SUTPHEN CORPORATION SALES TECHNICAL BULLETIN

CUSTOM CHASSIS DASH REDESIGN

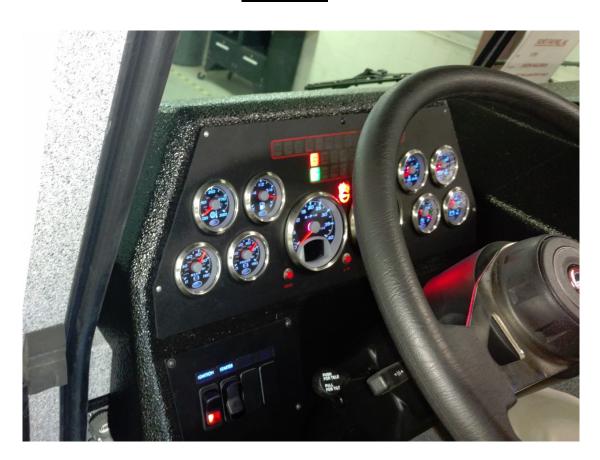
In an effort to create a more cohesive look inside our custom chassis, Sutphen will be implementing a new dash design into production. A molded housing, coated with the same urethane finish as the lower command console and engine enclosure, will replace the vinyl covered housing. The urethane coating will provide a more durable finish that is also easier to repair than the vinyl.

The urethane coating on this dash housing will match the lower command console and engine enclosure, unless otherwise requested.
